PART - GROUP CHANGE NOTIFICATION				Bulletin no	2011-35	Date	17.10.2011
	Prepared by	Musa ALTIPARMAK			Signature			
	Approved by	Alper AYDINAY						
Copy to	TH-YPLB		ÇMI-MTK1		ÇMI-ÜPB		ÇMI-MÜT	
	ÇMI-KGB		ÇMI-MTK2		ÇMI-MTK3		Other

Issue Change in the sheet metal screw of top table

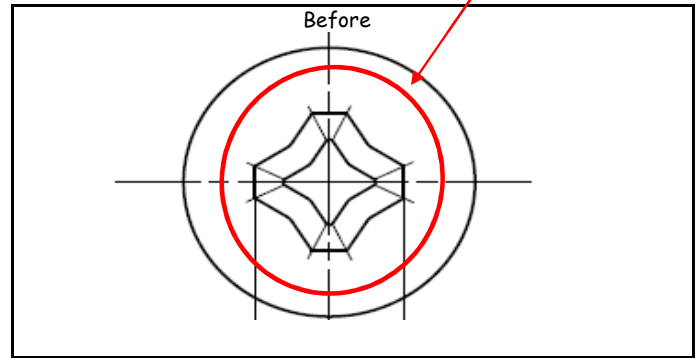
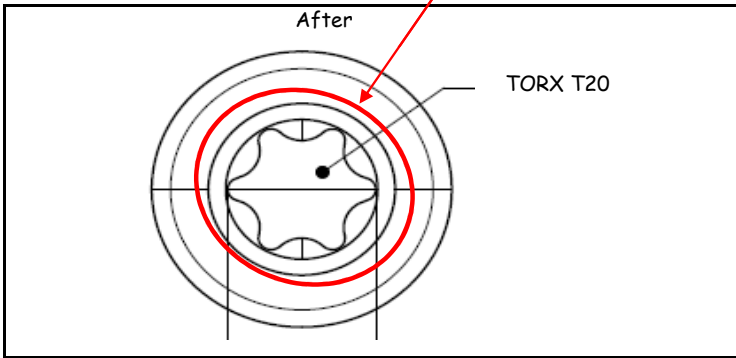
Explanation 9003610100 sheet metal screw (2 pcs.) has been removed and 2836970100 sheet metal screw (2 pcs.) has been added to the product tree . This change has been done to enhance and to protect the torque value during product lifecycle.

Ser. Ref	New part(s)			Code	Ser. Ref	Old Part(s)			Code
	Stock number	Part name	Adet			Stock number	Part name	Adet	
1096	2836970100	SCREW	2	B1	8397	9003610100	SCREW (B4.2x9.5-TIRTILLI)	3	B1
